Subject: Engine wiring.

Applicability: DG-400's with works numbers 4-1 to 4-178 inclusive.

Technical Note TN 826/19 Page 3 of 3

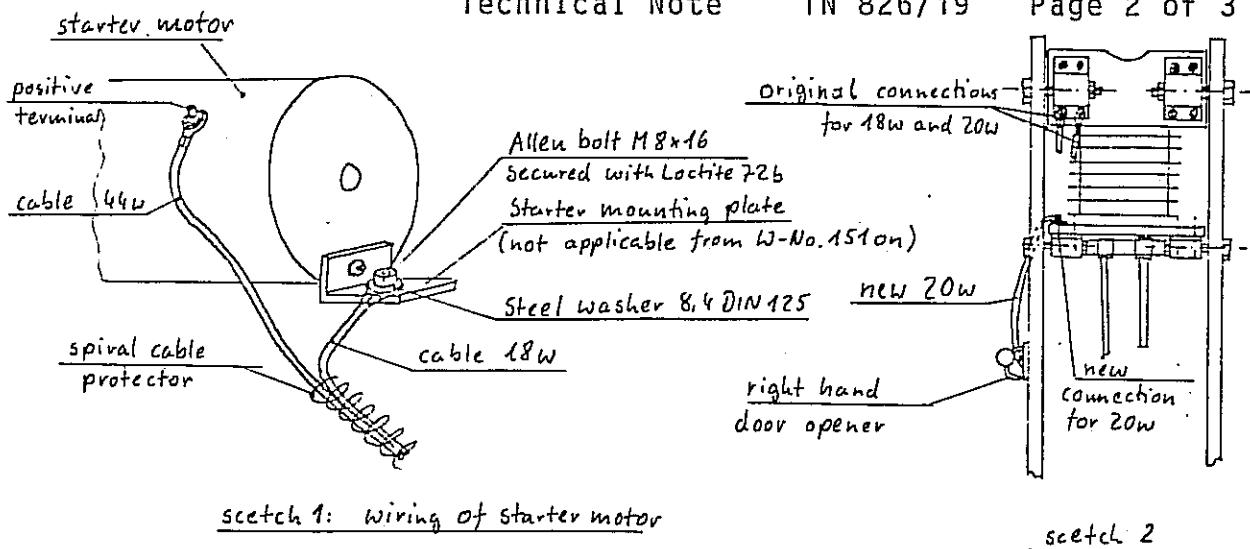
Visually inspect the terminals of the following cables for any signs of wear, chafing or cracks:

- a) 44 w : The positive cable at the starter motor; see sketch 1.
- b) 18 w : The ground cable between the engine frame and the upper right engine mount. (see scetch 2)
- c) 20 w : The loop of cable between the upper right engine mount and the right-hand engine door opener.

To remedy this the cables 18 w and 44 w have to be modified with reinforced terminal connectors, and for DG-400s with works numbers 4-1 to 4-105, cable 20 w is being replaced with a thinner, more flexible cable.

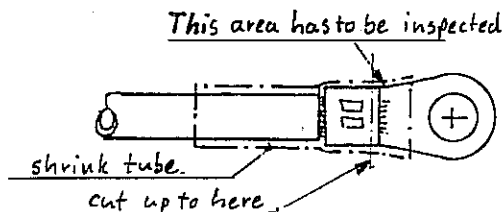
Note: Before making the visual inspection of the terminal connectors the heat-shrink tubing on the connectors must be cut back as shown below:
